**Item #2:  
Report Of September 15, 2014 AC Meeting:**

TO: Village President and Village Board  
FROM: James M. Hogue, Village Planner  
DATE: September 16, 2014  
RE: Board & Commissions Report for 9/22/14

**Report Of September 15, 2014 AC Meeting:  
Signage For Sherwin Williams, Sunset Grove**

**Report Of September 15, 2014 AC Meeting:  
Facade Improvements For The Arlington**

NORTH ELEVATION

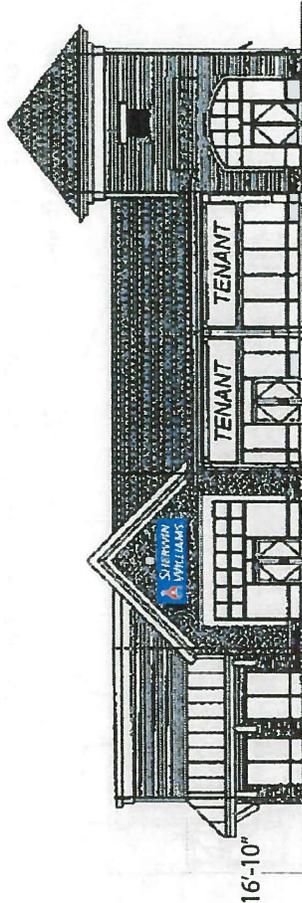
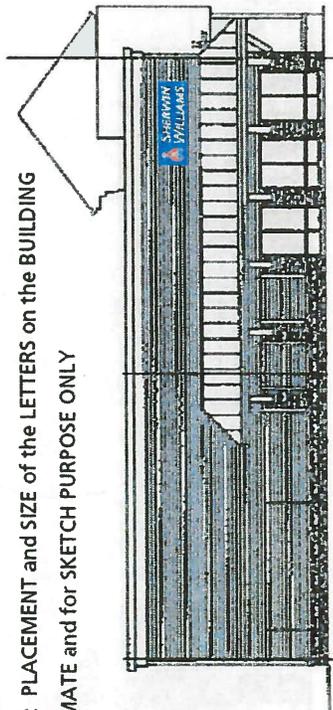
Planner Hogue reported that at the August 18<sup>th</sup> regular AC meeting it was noted the proposed signage is on the east elevation is within the allowable square footage for such signage as allowed by the PUD approval ordinance, however the square footage of the signage on the north elevation appears to exceed the maximum allowable square footage by 4.2 square feet.

Staff has since received a revised "proof" for the north elevation. The square footage of the signage on the north elevation is revised as follows;

The AC had a concern with the sign placement in relation to the gable roof and indicated the sign should not be part of gable and be equidistant for the edges of the roof gable.

A motion was made by Commissioner Styer, seconded by Commissioner Tapas to recommend approval of the sign as submitted subject to the sign being mounted within the designated zone for placement of signage and graphics but equidistant for the edges of the roof gable. On a voice vote; all aye.

NORTH ELEVATION

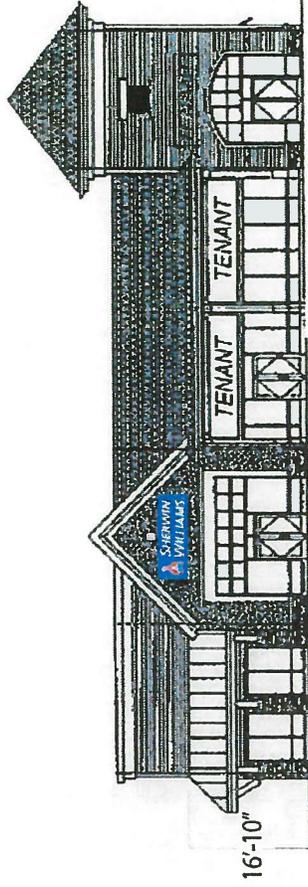
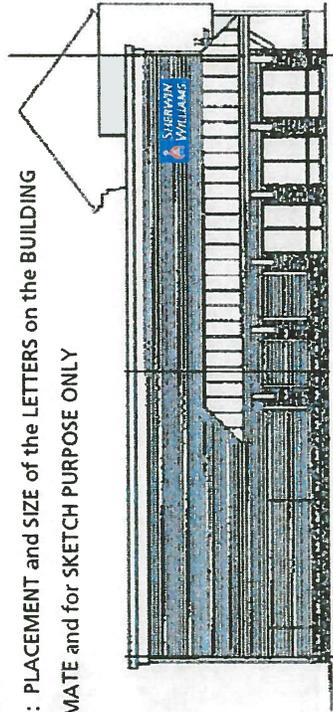
*At the August 18<sup>th</sup> regular staff noted the proposed signage on the east elevation is within the allowable square footage for such signage as allowed by the PUD approval ordinance, however the square footage of the signage on the north elevation appears to exceed the maximum allowable square footage by 4.2 square feet.*

*Staff has since received a revised "proof" for the north elevation. The square footage of the signage on the north elevation as revised appears to be at the maximum allowable square footage (10.7' x 3.1' – 33.17) square feet. Per the Village Code the square footage of signage is calculated as follows;*

*No changes are proposed to the signage for the east elevation. As revised the proposed signage is now approvable from the Village Code/ PUD approval perspective. The previously prepared report, slightly modified to reflect the revisions is attached below for reference.*

Signage as proposed is permissible under the approved PUD Ordinance.
